Re: 126 Main Street – Gas Station and Convenience Store
Response to 7/16/2025 PZA Memorandum

Re: 126 Main Street
Monroe, CT

This letter is in response to comments from the Town Engineer. The comments and the response are as follows:

SP-6

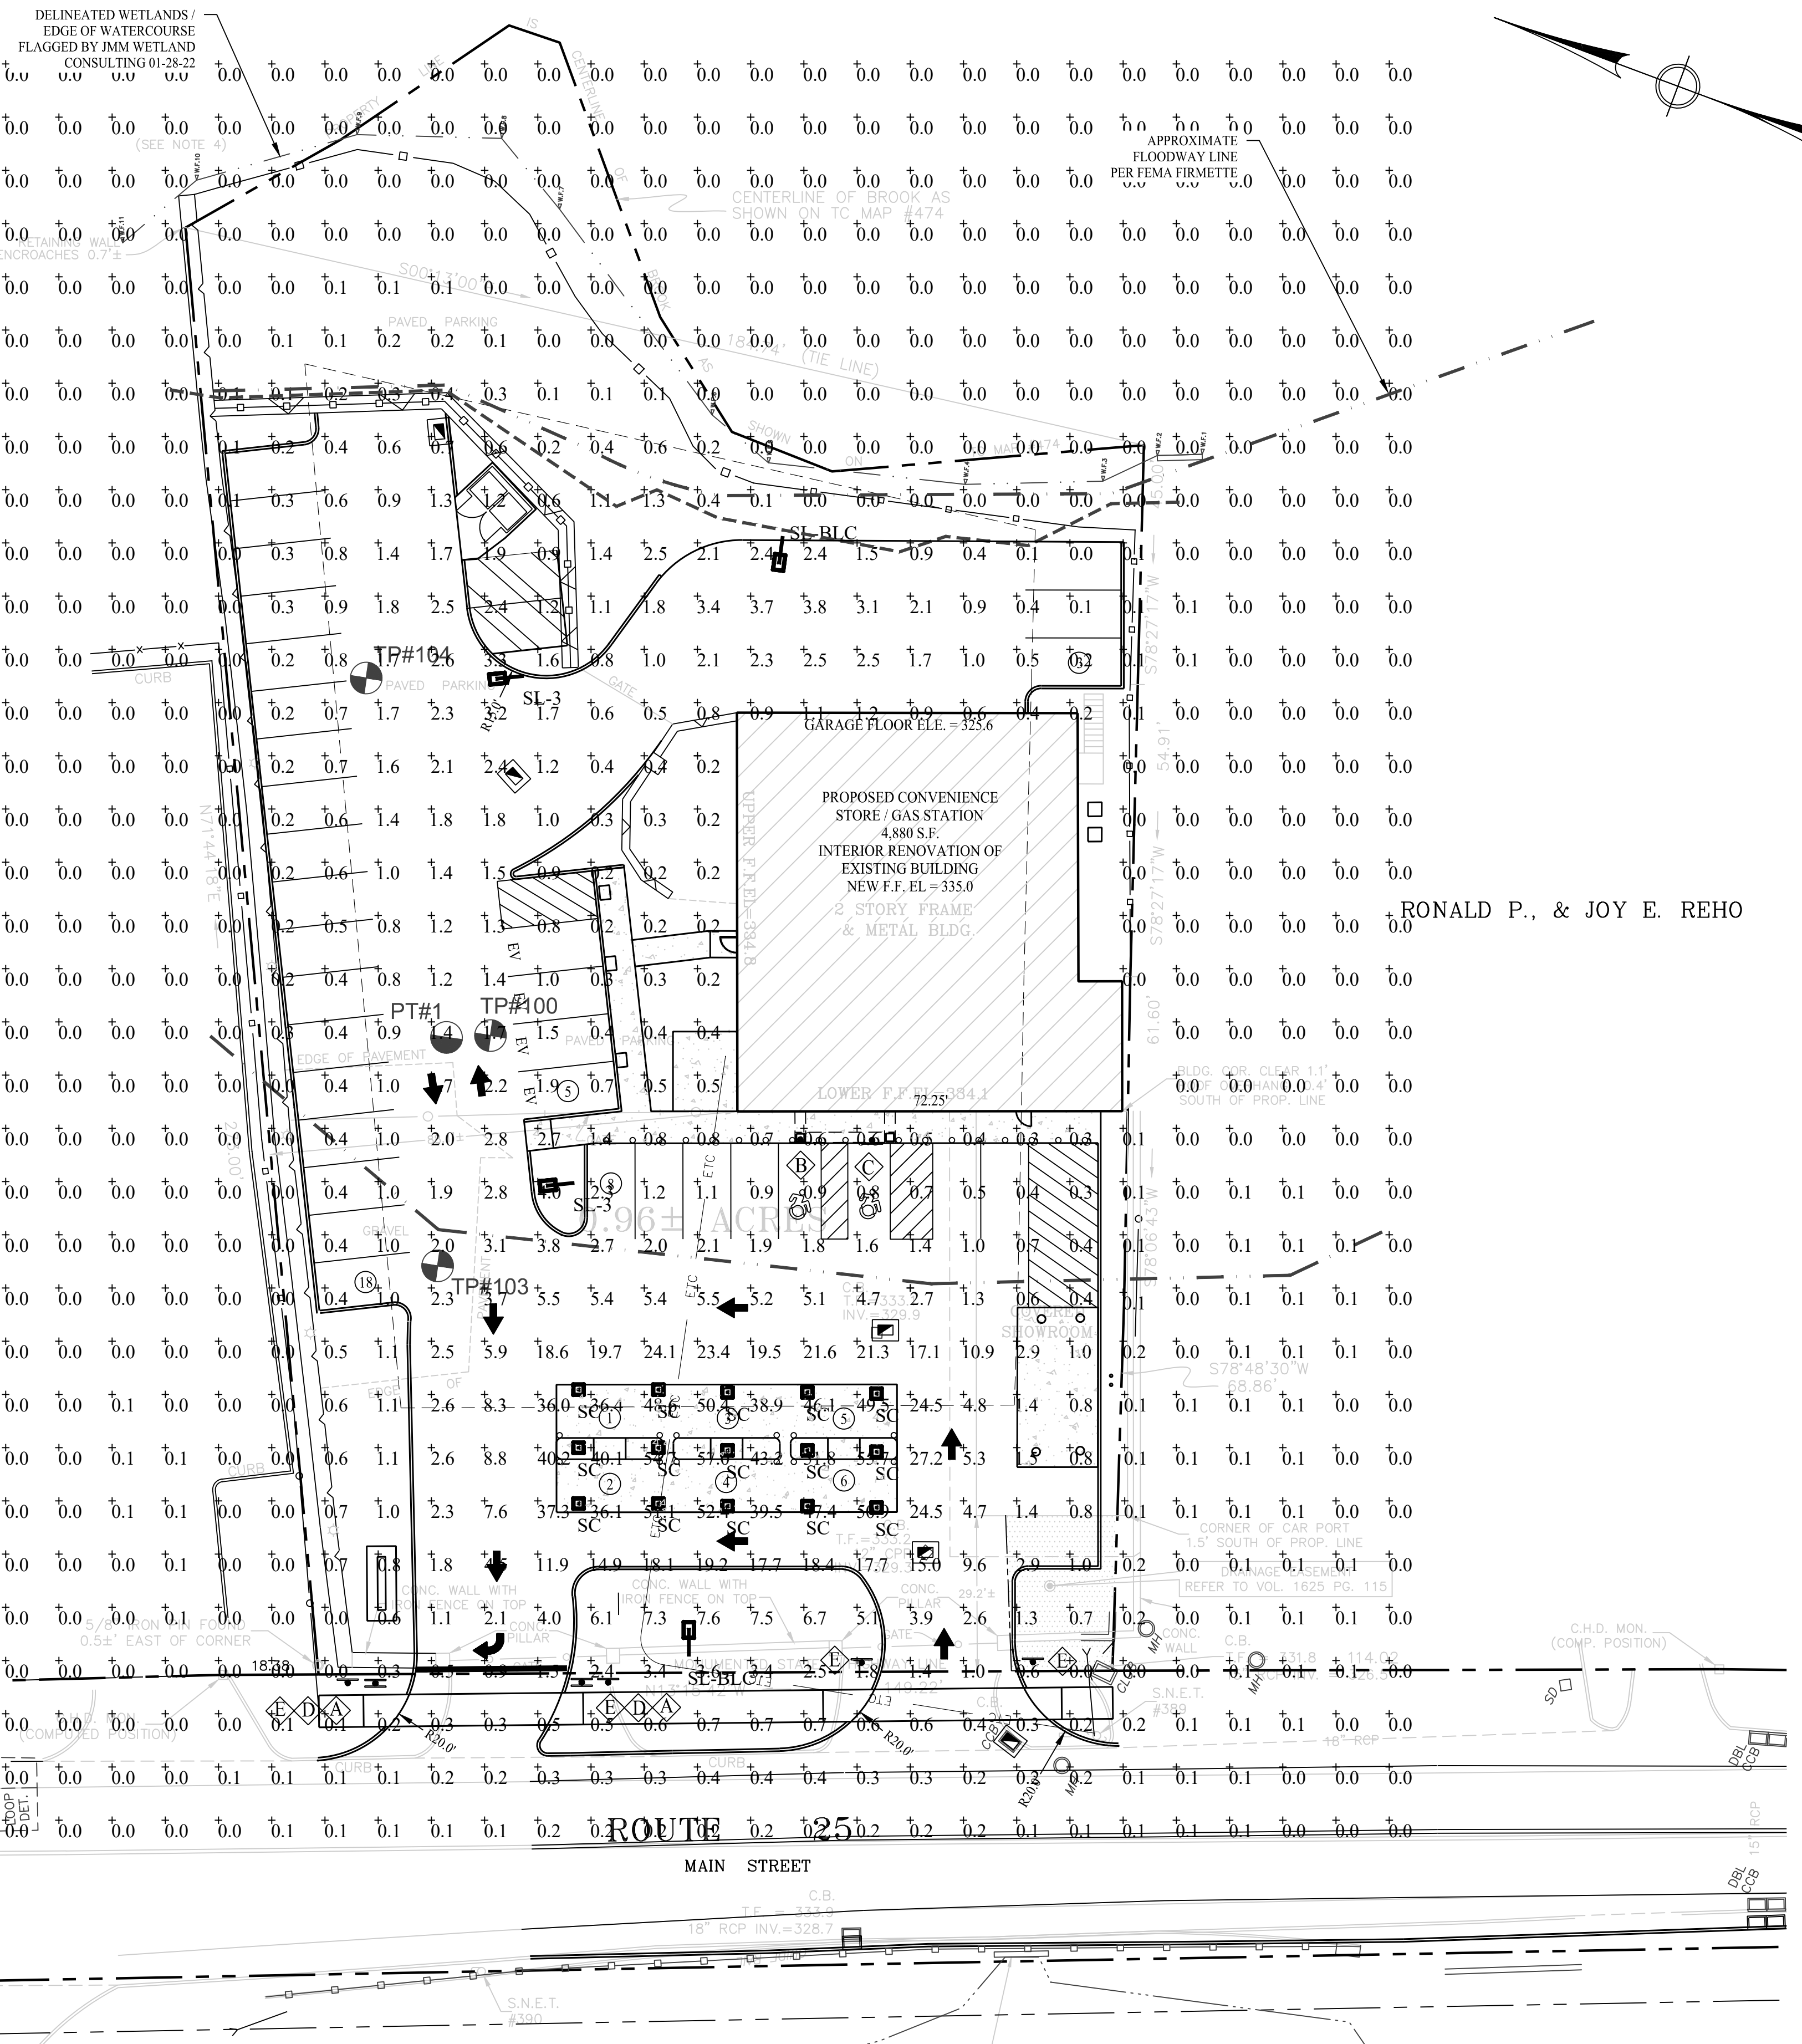
7. Lighting: Per 6.2.2 F (7) "An applicant shall demonstrate to the satisfaction of the Commission, that the light level at any lot line shall not exceed one-quarter (0.25) footcandle measured at ground level and that there shall be no adverse light spillage off the property or over wetland or watercourse resources." Applicant should revise the plans to meet lighting requirement.
See revised SP-6 along East Property Line.

1. Lighting shall not exceed 0.25 FC @ any property line, See southern property line.

3. Some of the canopy lights do not appear to be located under the proposed canopy. This should be revised.

R. Lighting plan has been revised.

R. Lighting plan revised.
